FIRE SAFETY INSPECTION REPORT

Factory Name: Designer Fashion Ltd

Date: 29th March, 2017

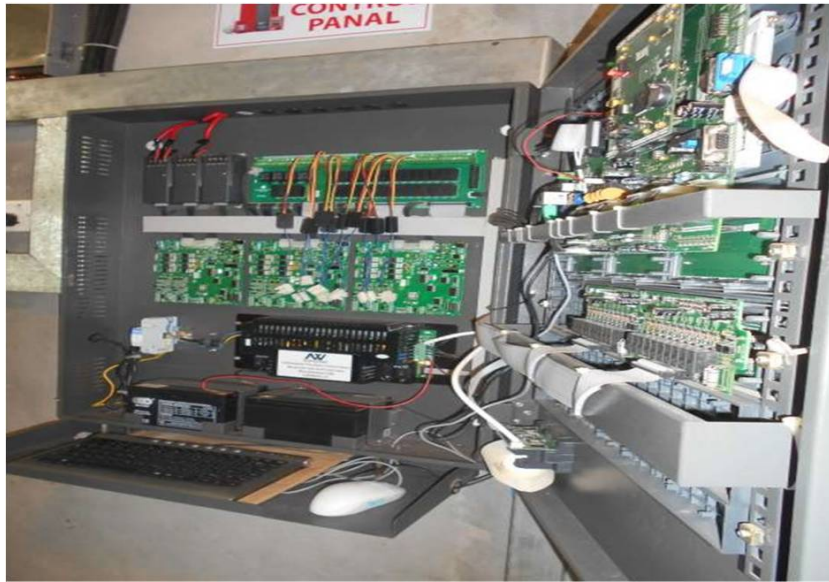
SI No.	Category	Findings	Required Action	Remediation Time Frame
5	Fire Rated Construction	Penetrations through floor/ceiling assemblies are found unsealed. Location: Different places at all level.	Seal all penetrations and openings in the wall of exit enclosure walls (full thickness of the wall) by fire rated materials to maintain the fire resistance rating.	Within 3 months
